Docket Item # 10
BAR CASE # 2008-0095

BAR Meeting
July 9, 2008

ISSUE: Addition and Alterations
APPLICANT: Stephanie Dimond
LOCATION: 725 South Columbus Street
ZONE: RM/Residential

Figure 1: Plat showing area of demolition/addition

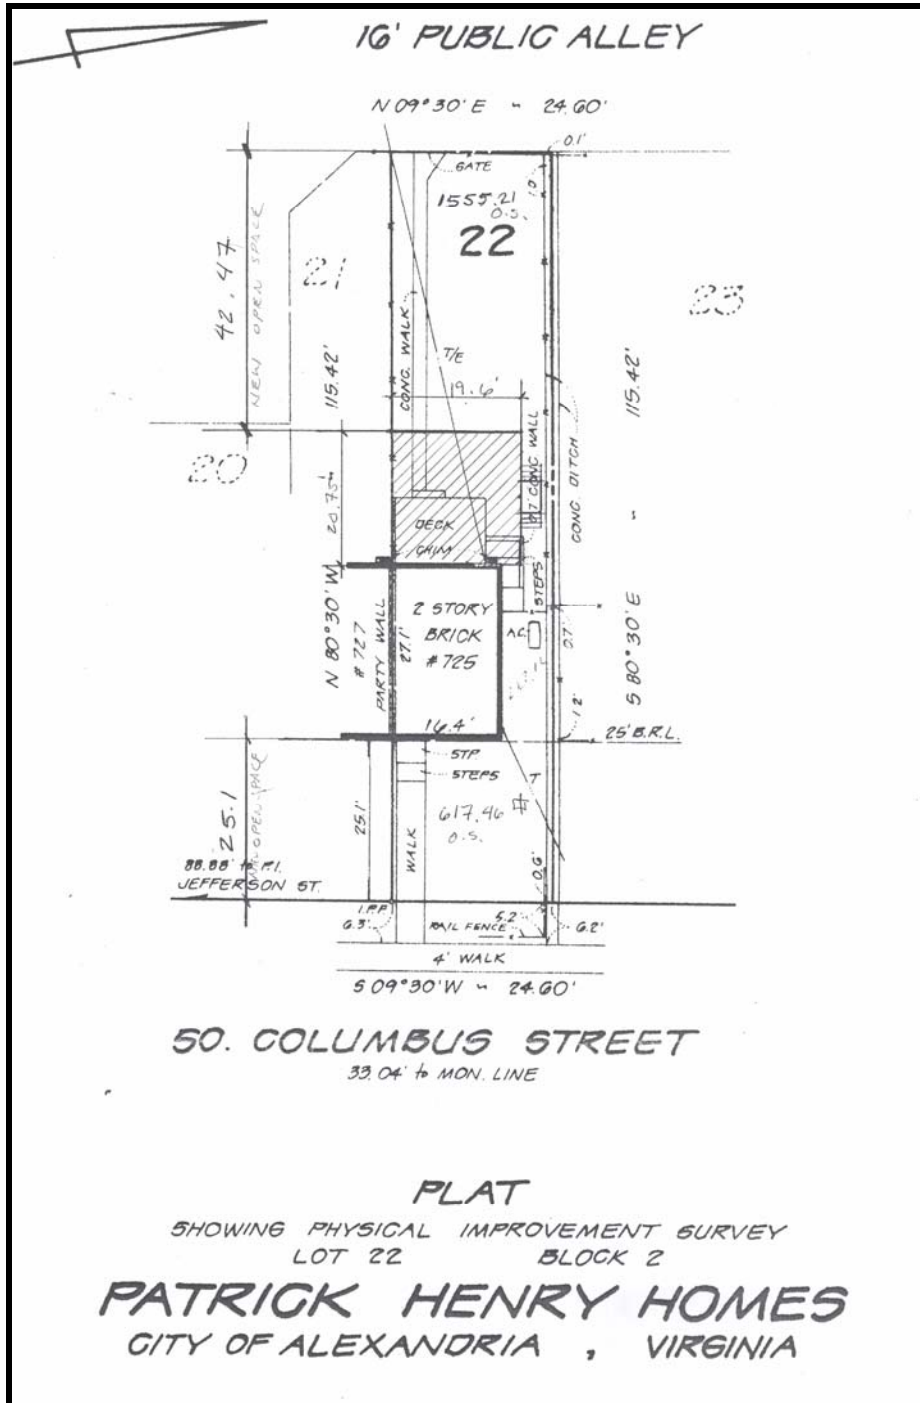
The applicant proposes to construct a rear addition measuring approximately 19.6' by 20.75'. The addition will project approximately 3.5' beyond the north elevation of the original house.

Figure 6: Existing elevations

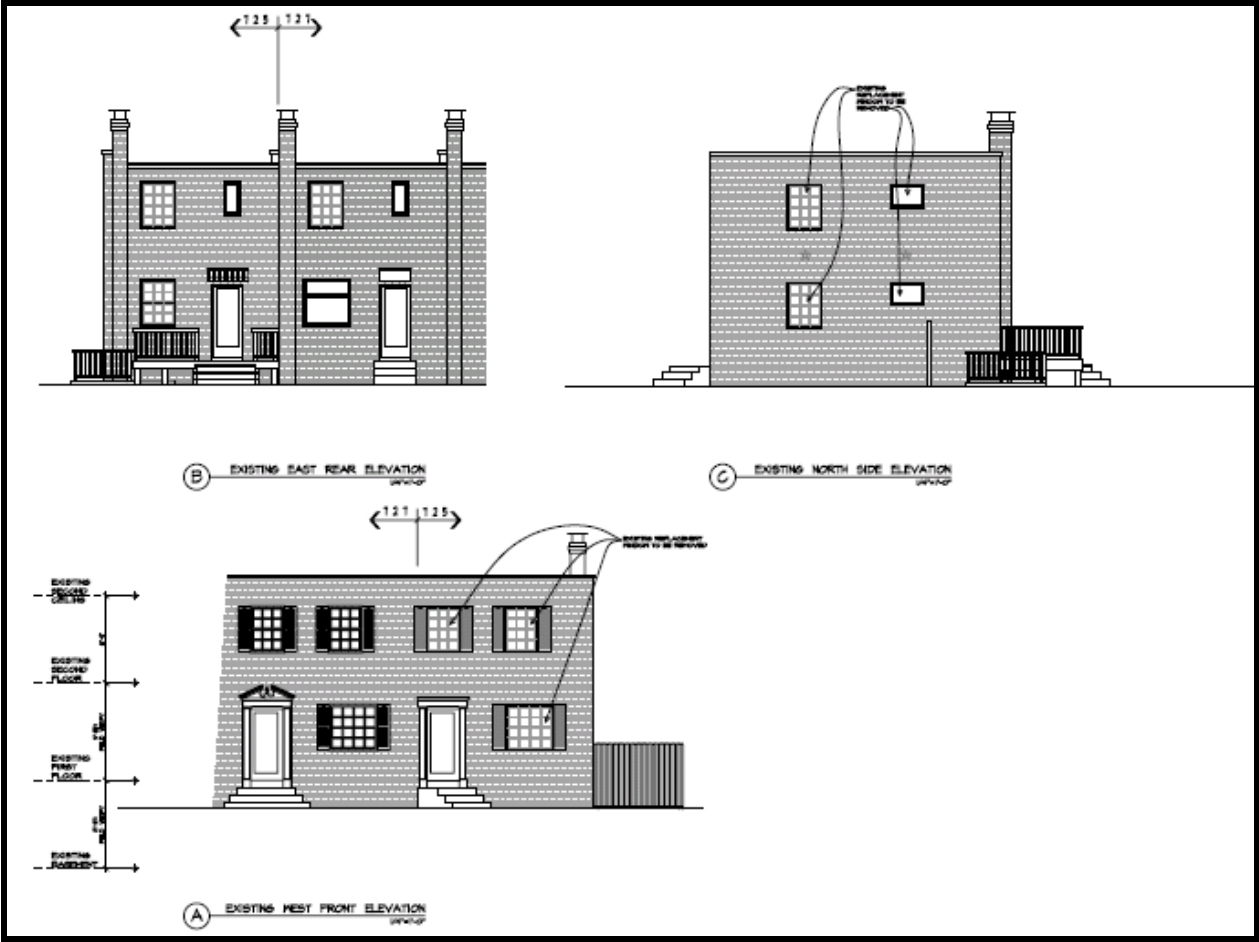
The existing double hung vinyl windows on the front and side elevations of the townhouse will be replaced with wood casement windows. The existing vinyl awning windows on the north elevation will also be replaced with new wood awning windows. The new wood windows will be painted and the existing vinyl shutters on the front of the house will be removed.

Staff commends the applicant for making appropriate alterations to the original part of the townhouse, namely the removal of the vinyl shutters and the replacement of the double hung vinyl windows with historically appropriate casement style windows.
